Addendum No. 1

Date: September 17, 2025
Invitation to Bid: 25-2866-8JL – Henrico County Animal Shelter Renovation
Receipt Date/Time: September 23, 2025 at 2:00 PM
Opening Date/Time: September 23, 2025 at 2:00 PM
Subject: Questions & Answers Modifications to the Project Manual, and
Modifications to the Drawings

FIRST FLOOR PLAN - DOMESTIC

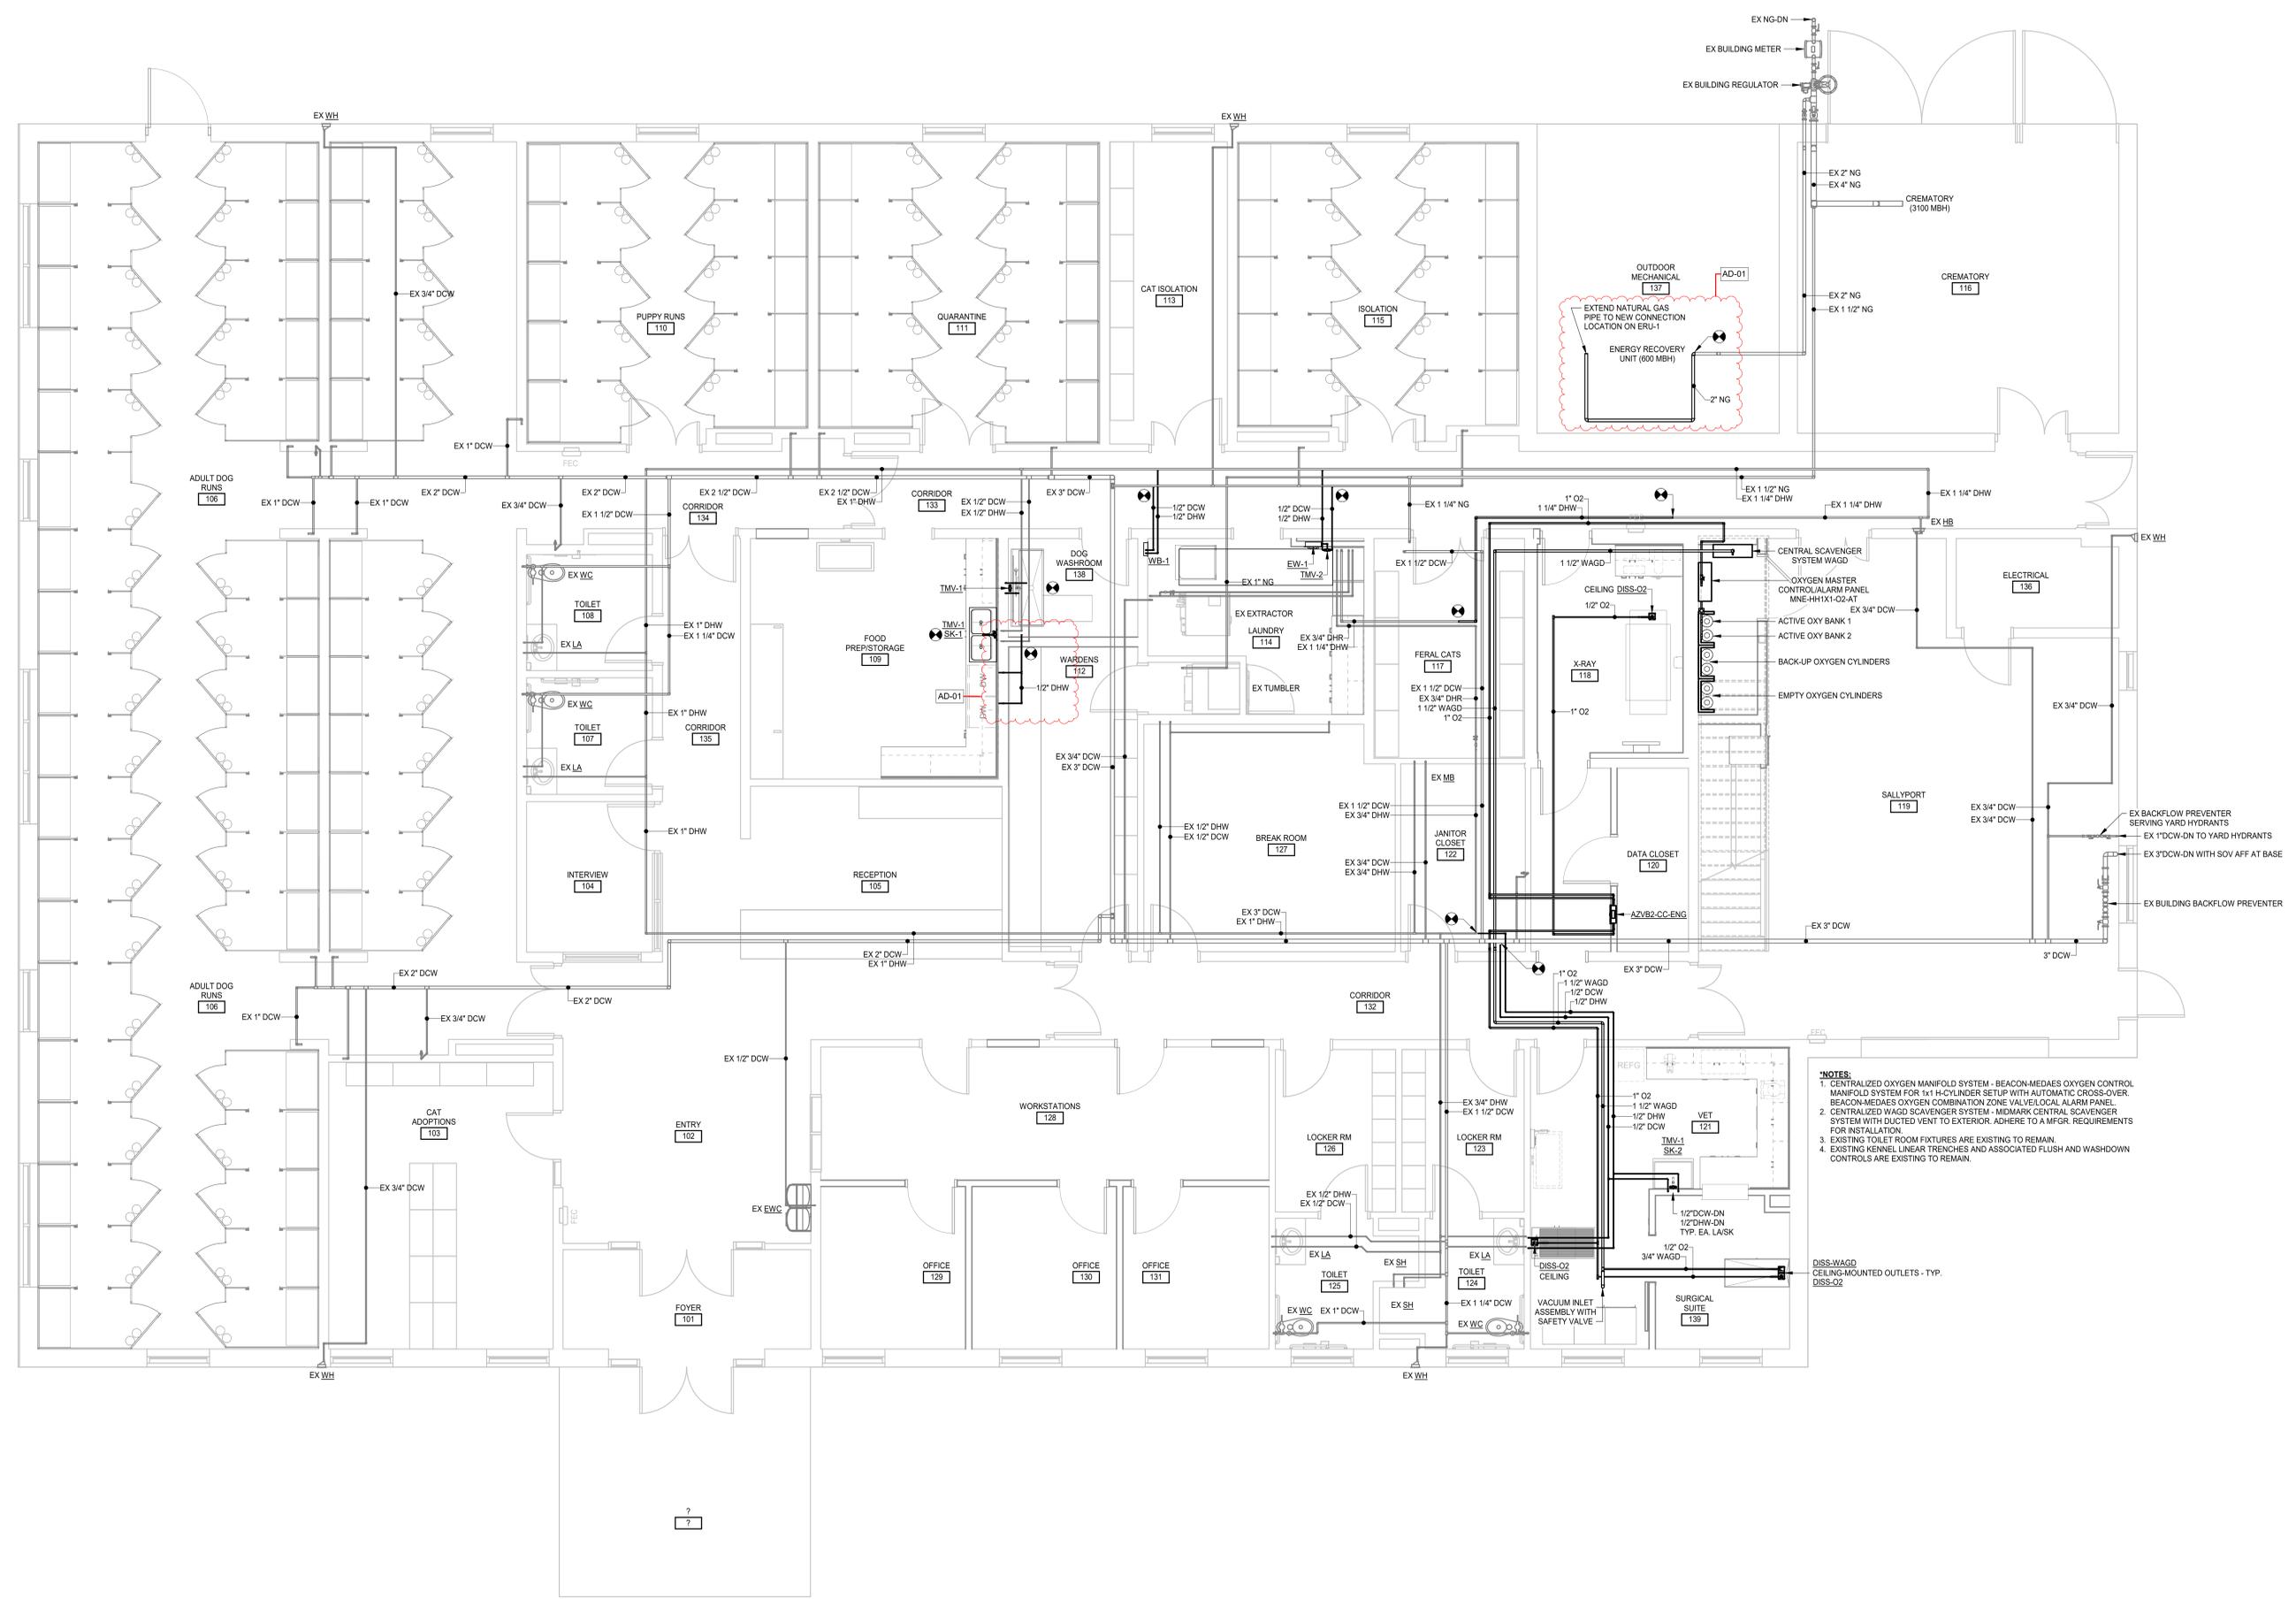
22. Question: Sheet P2.2 – Room #109 new plumbing indicates two new DCW hookups for the Dishwasher locations. The Basis of Design Manufacturer and reference note 4 on P6.1 indicate a DHW hookup. Please clarify.

[Answer: Refer to revised drawing P2.2 indicating DHW connection to dishwasher units.](#)

FLOOR PLAN - DEMOLITION
1/8" = 1'-0"

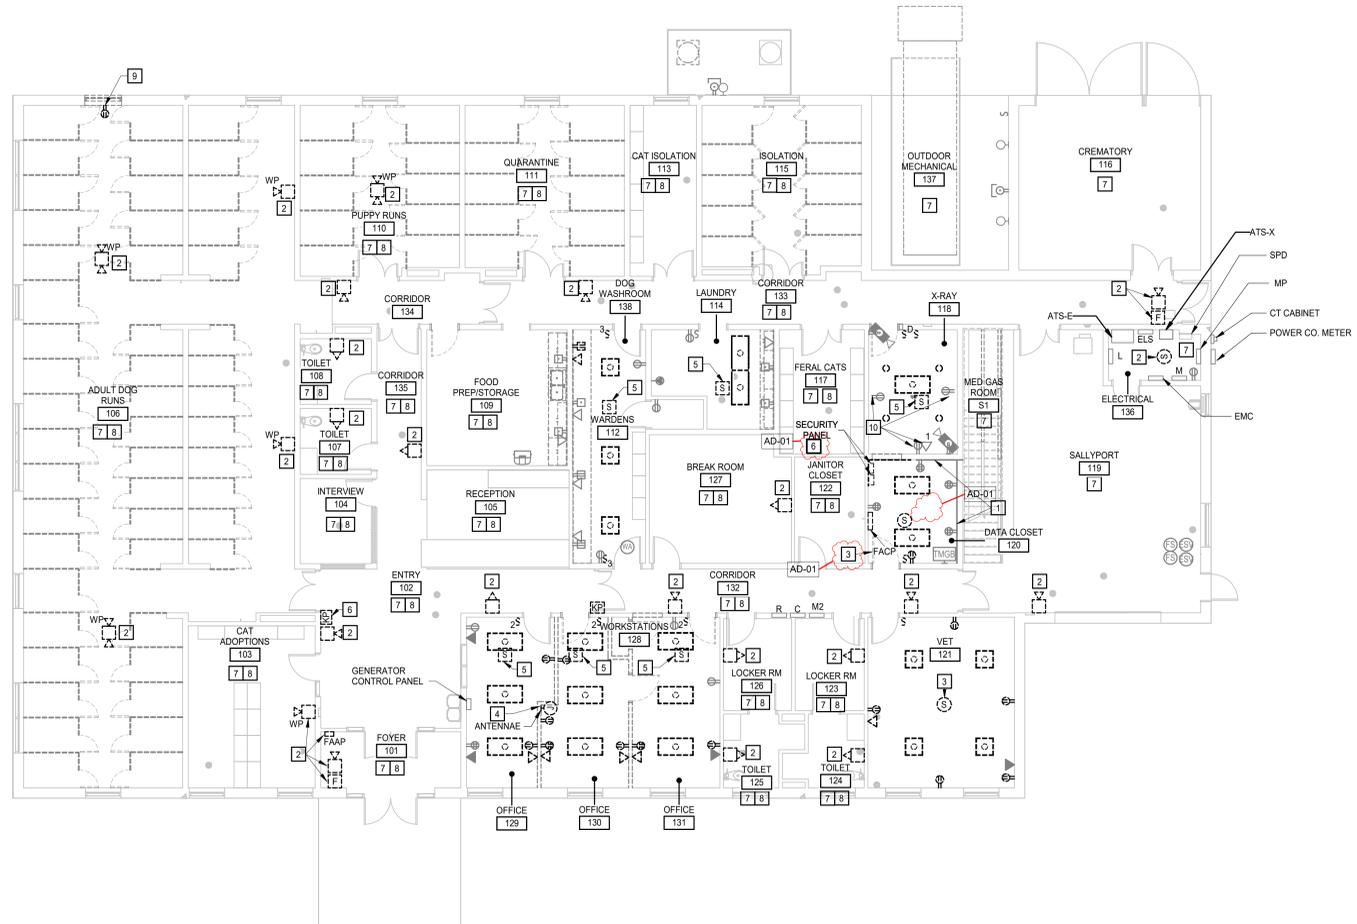
21. Question: Sheet E1.2 – Existing Security panels indicated on plans do not show any associative work. These are shown with a dashed line for associated Selective Demolition scope. Please clarify if these existing security panels are to be relocated, returned to owner, or disposed of.

[Answer: Refer to updated drawings E1.2 & E2.1.3.](#)
